Agenda Date: 11/16/2020

Agenda #: 3. **File #:** 15-14591 **Type:** Zoning Decision

Rezoning Petition: 2019-085 by American Asset Corporation

Zoning Committee Recommendation

REQUESTED TECHNICAL REVISIONS

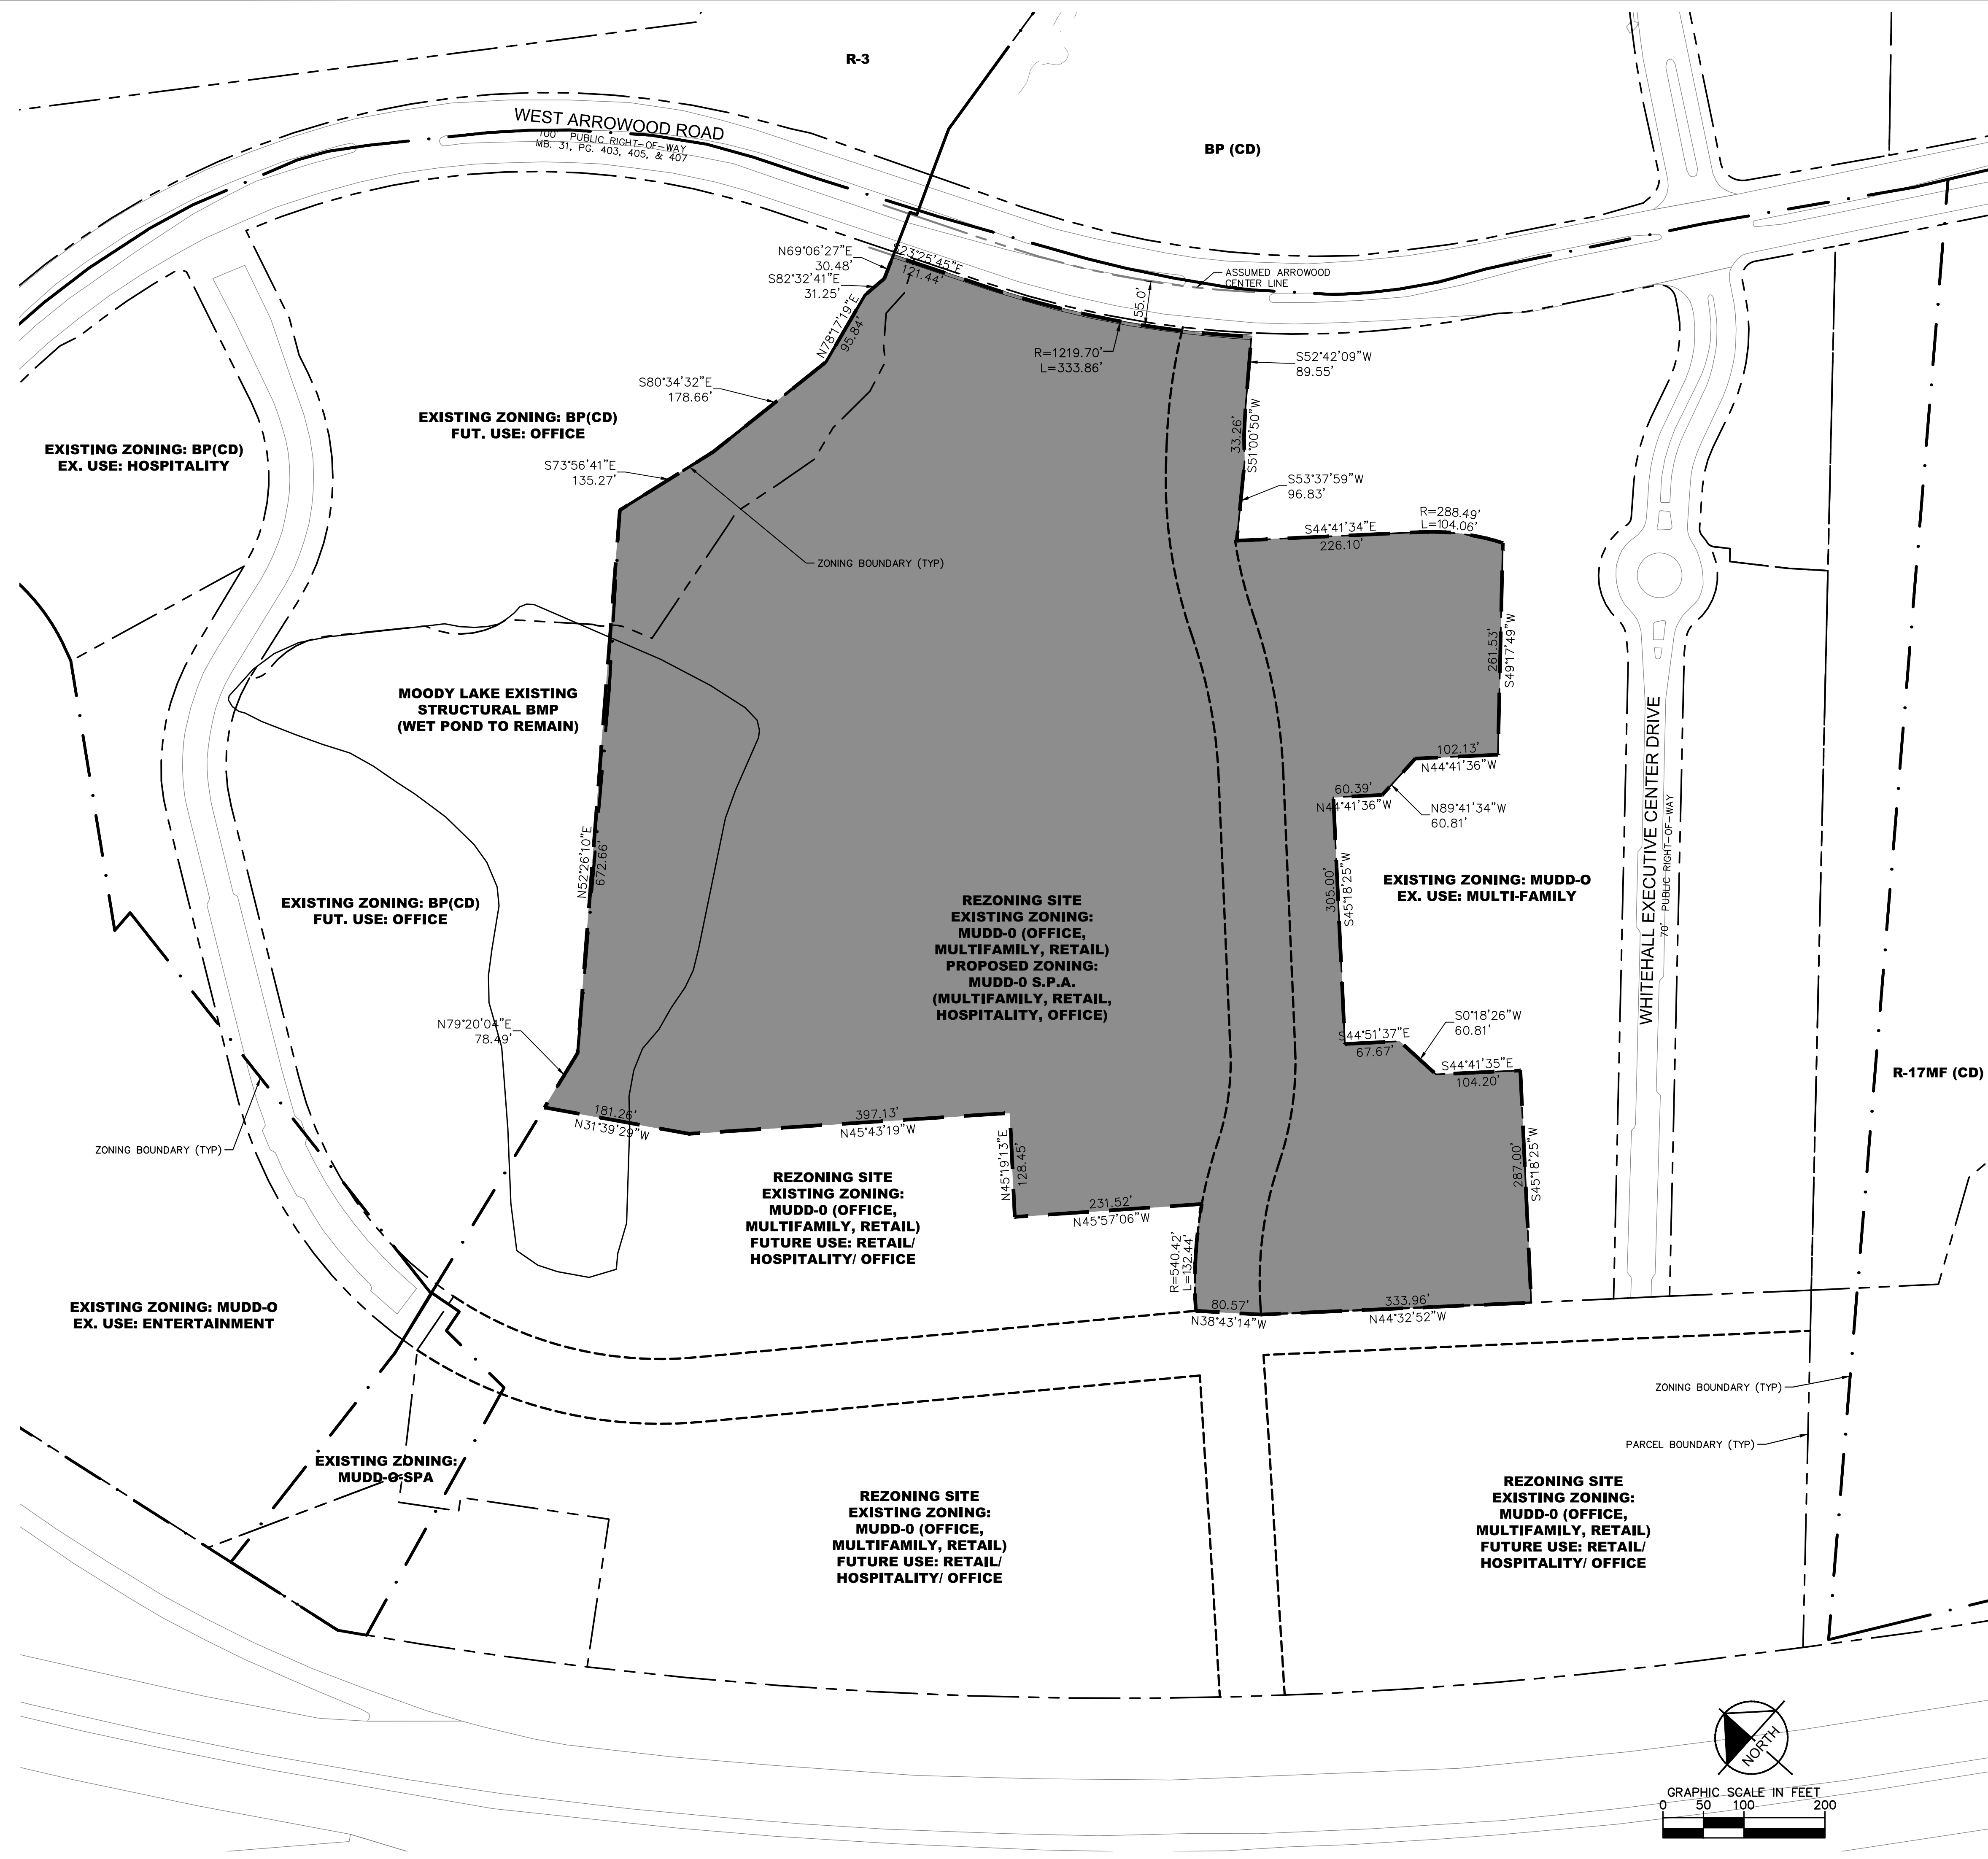
1. ~~Update the multi-use path language to have the MUP constructed in accordance with City of Charlotte's multi-use path standards as shown in detail 10.42 of the CLDSM.~~ - **RESCINDED**

2. ~~Provide clarity as to where the optional provision will be implemented in the site and denote on site plan.~~ **RESCINDED**

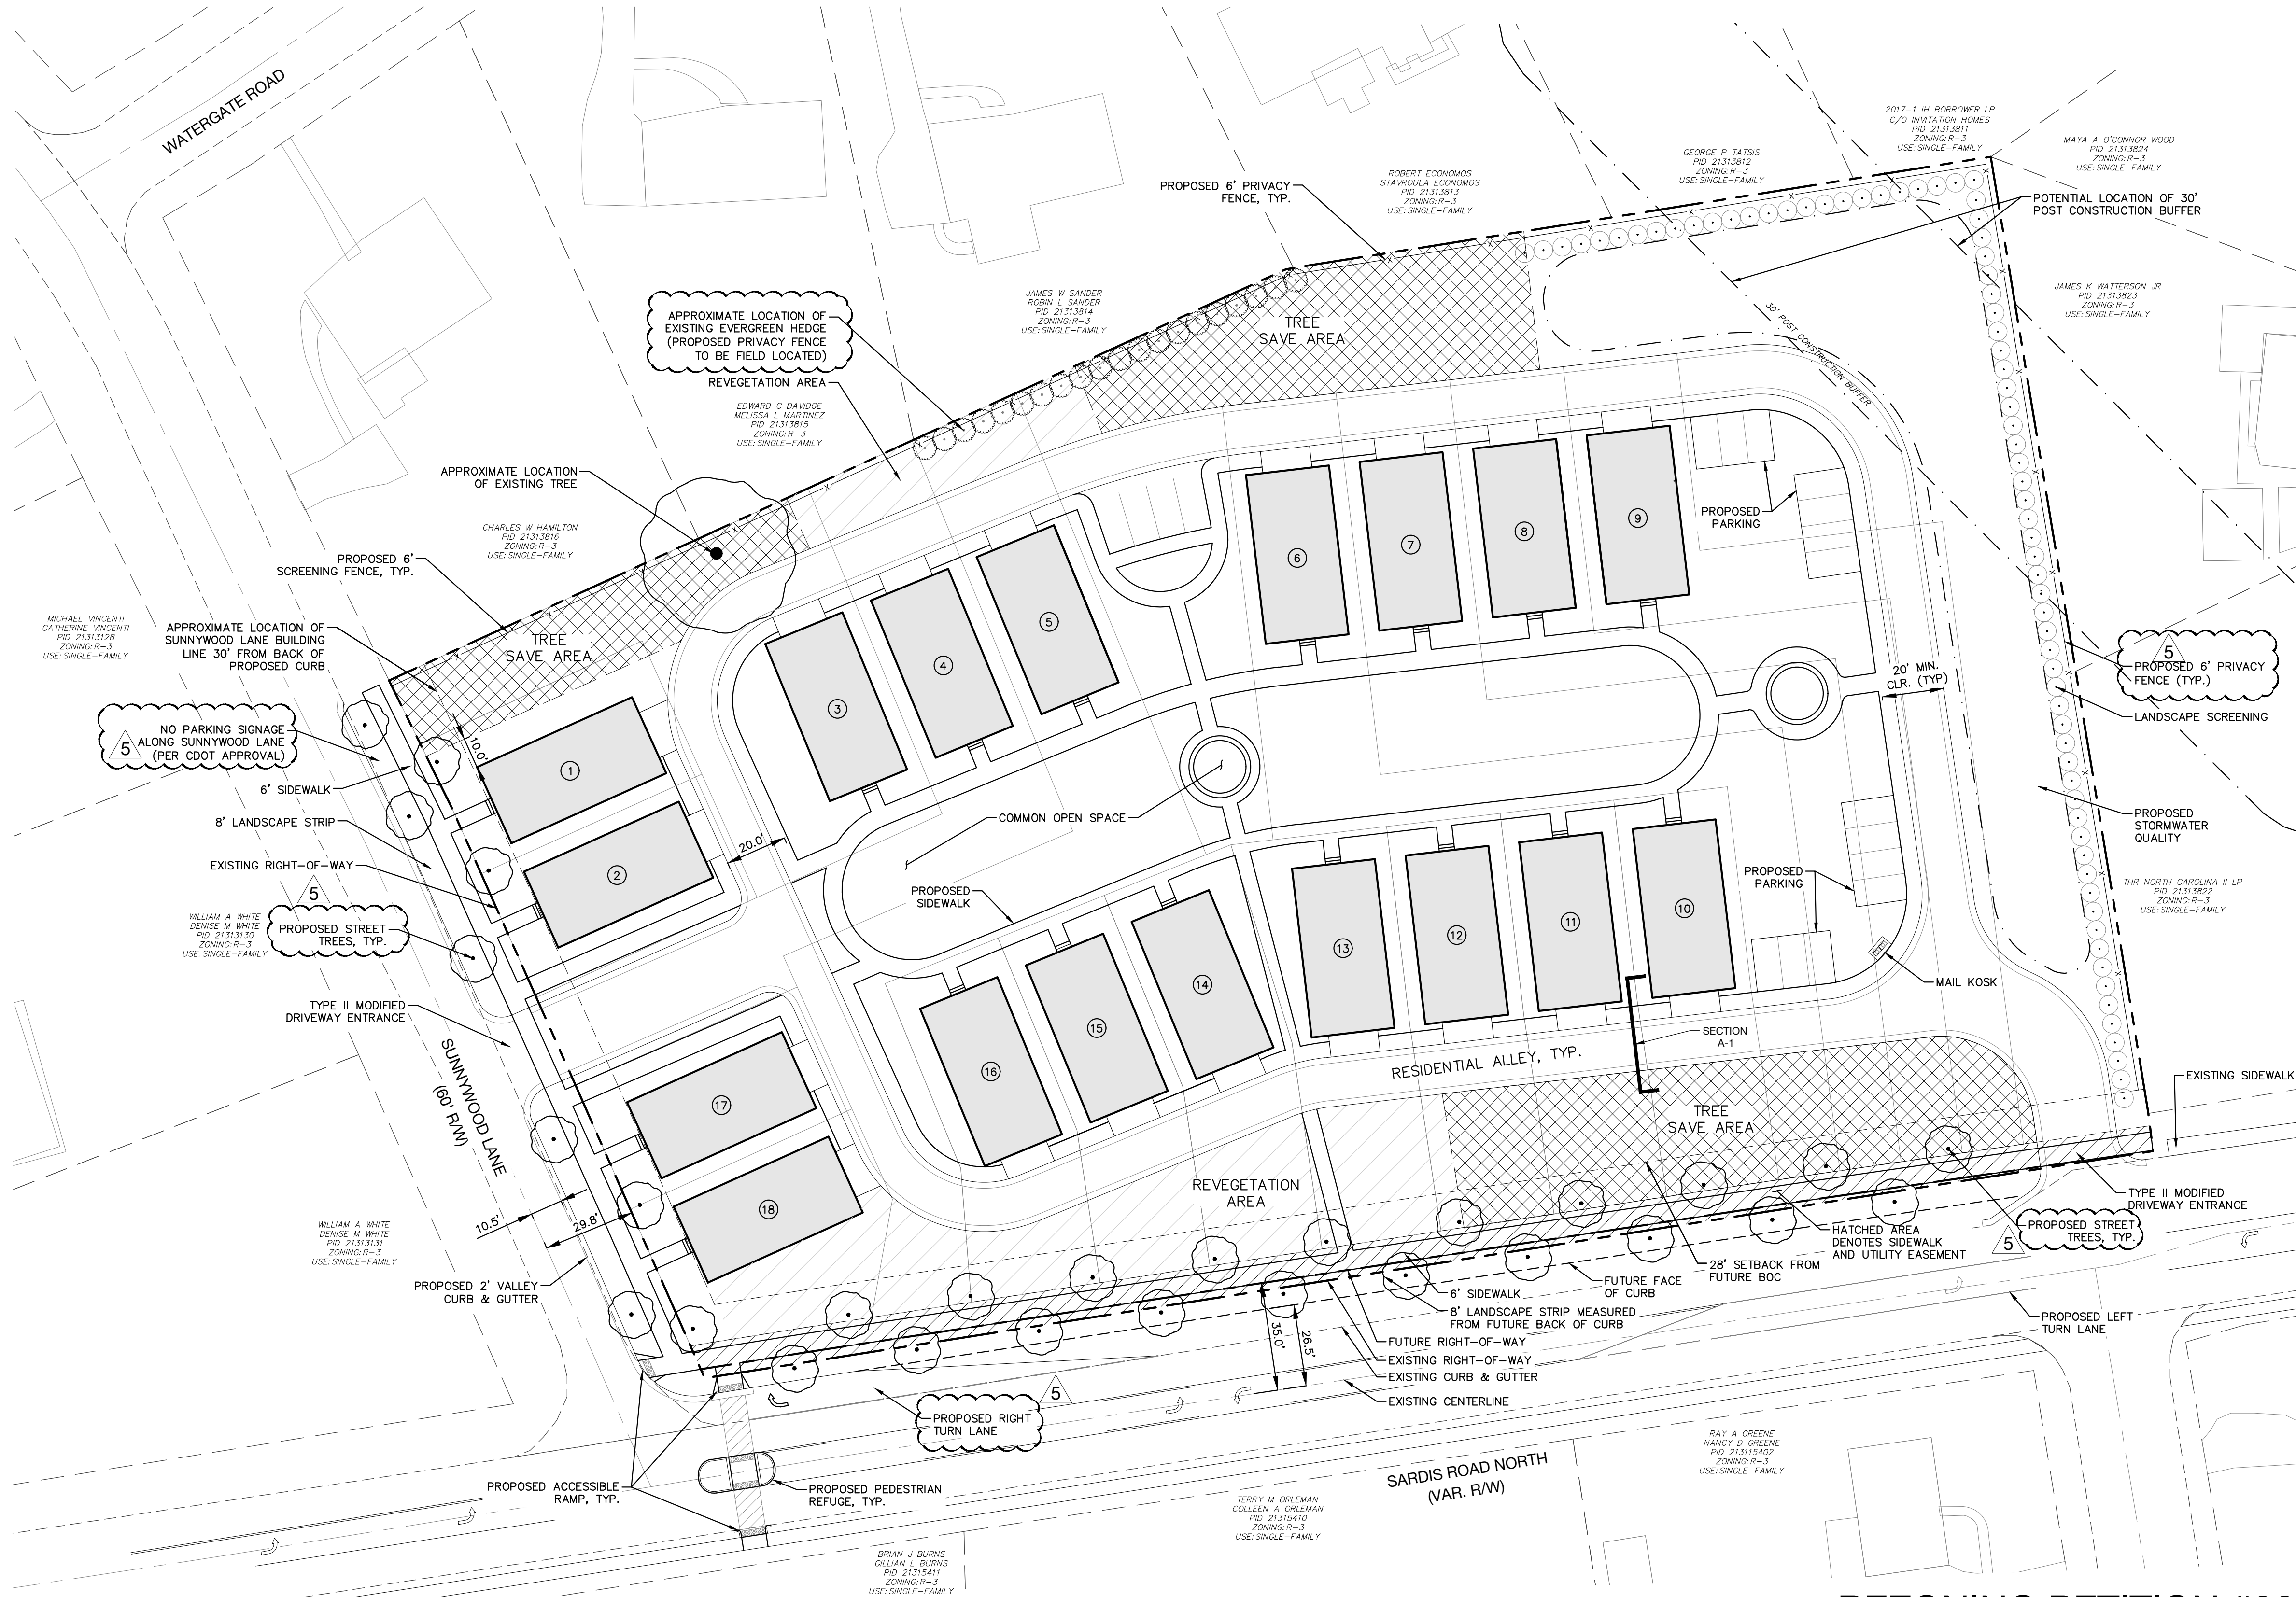
1. Amend the first and second sheets to show and label the setback along Sardis Road North. They should match and commit to the provided setback that is depicted which appears to be roughly 28 feet from the future BOC. **ADDRESSED**
2. Amend the lot dimensions table on sheet 2. Setback should be measured from the future BOC. The setbacks depicted are greater than the minimum 14ft. The table should show 30' from future back of curb for Sunnywood Lane and minimum of 28' from future back of curb along Sardis Road North. **ADDRESSED**
3. Amend the second sentence of note 4a. to say "Along Sardis Road North a building setback with a minimum of 28 feet was measured from the future back of curb will be provided" **ADDRESSED**

6. On sheet 1 amend the label for the building line along Sunnywood Lane to change "existing" to "proposed" **ADDRESSED**
7. Amend the lot dimensions table on sheet 2. Setback should be measured from the future BOC. The setbacks depicted are greater than the minimum 14ft. The table should show 30' from future back of curb for Sunnywood Lane and minimum of 28' from future back of curb along Sardis Road North. **ADDRESSED**
